REMARKS

Reconsideration and allowance of the above referenced application are respectfully requested. After entry of this amendment, claims 1-20 will be pending in the case.

Attachment: Proposed drawing change.

Fig 1

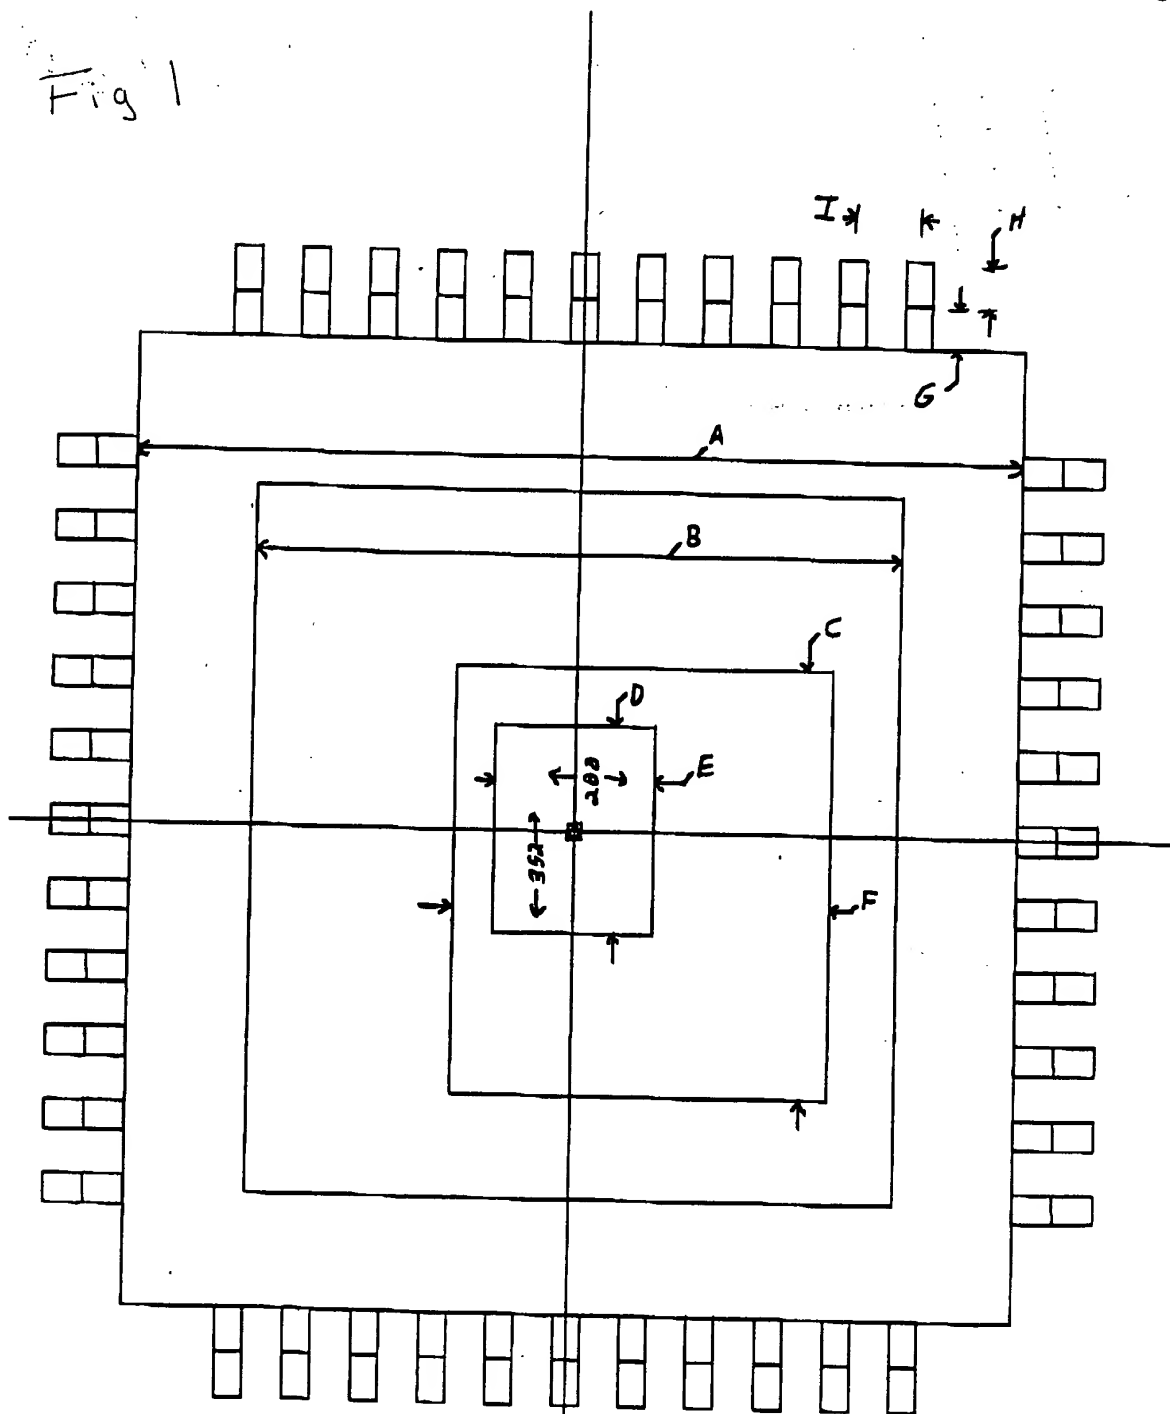
The drawings stand objected to due to informalities. In response, figures 1 and 2 has been amended to include the missing reference signs. The objections to claim 4 have been obviated by the amendment of the preamble of claim 4. The antecedent basis objections have also been corrected.
